SUBJECT: SUMMARY OF MEETING HELD ON OCTOBER 11, 2005, WITH THE WESTINGHOUSE OWNERS GROUP TO DISCUSS RESUBMITTAL OF WCAP-16168-NP, "RISK-INFORMED EXTENSION OF REACTOR VESSEL INSERVICE INSPECTION INTERVAL"

OFFICE OF NUCLEAR REACTOR REGULATION STAFF'S COMMENTS
ON THE TECHNICAL BASIS FOR THE PTS RULEMAKING TO REVISE 10 CFR 50.61
PREPARED BY THE OFFICE OF NUCLEAR REGULATORY RESEARCH
AS DISCUSSED IN THE MEETING WITH WOG ON RESUBMITTAL OF WCAP-16168
ON OCTOBER 11, 2005

Figure 6.20. Reactor Vessel Downcomer Fluid Temperatures - MIST Test 4100B2.

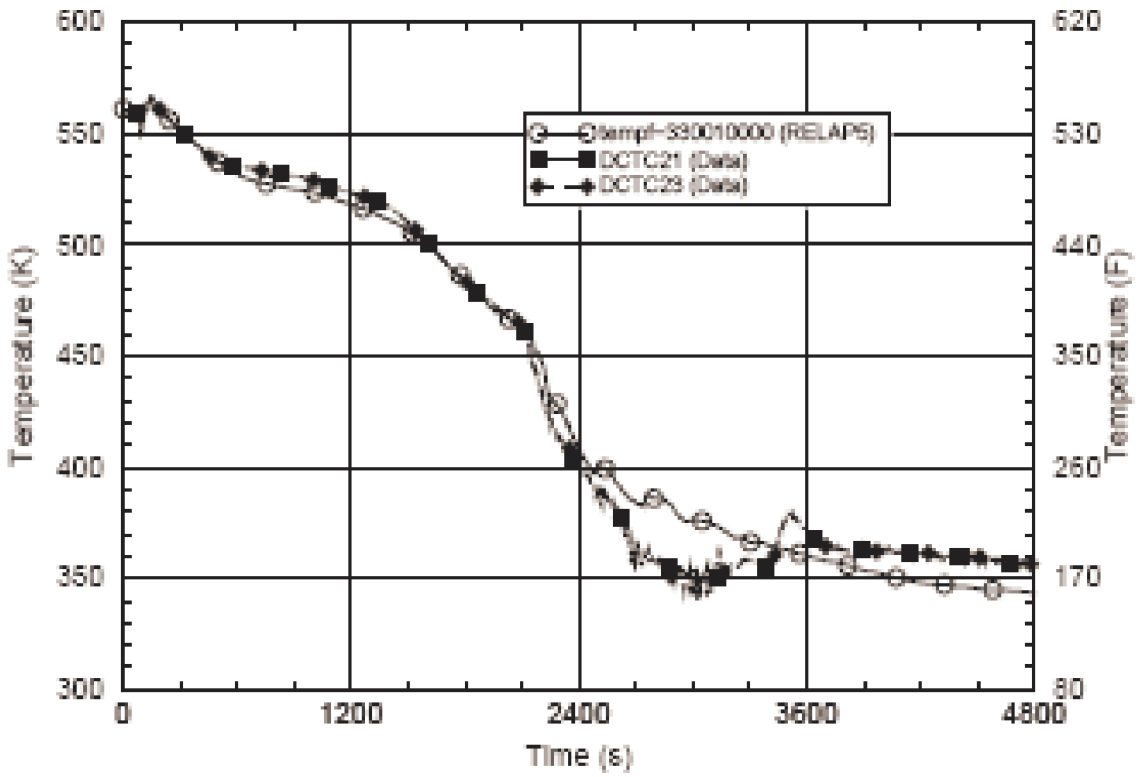
Based on review of only the few comparisons of RELAP results to test data that are contained in NUREG-1806, the Multi-Loop Integral System Test (MIST) Test 4100B2 shown in Figure 6.20 (shown on next page) on page 6-123 seems like a possible candidate for significant under-prediction of the thermally-induced

stress. It shows an over-prediction of temperature during a small time segment at a temperature of approximately 170° F. The maximum temperature difference is about 58° F, and it occurs at the point where the time derivative of the temperature is most under-predicted. Consequently, it seems like the stresses predicted from the RELAP results are likely to be less than the stresses predicted from the MIST data at time when the metal temperatures are low enough to create a non-zero probability of brittle fracture. The NUREG-1806 text does note this, but ends with a statement that RELAP over-predicted the downcomer fluid temperature by an average of 0.67° F over the entire test period. Nothing is said about the significance of the period when the temperature is over-predicted and its time derivative is significantly under-predicted. Please discuss, and quantify to the degree possible, the effects on TWCF of the absolute difference in temperature and the difference in the rate of change of temperature between experimental observations and RELAP calculations. Please perform this evaluation for the range of available test data rather than just for this example of MIST test data.
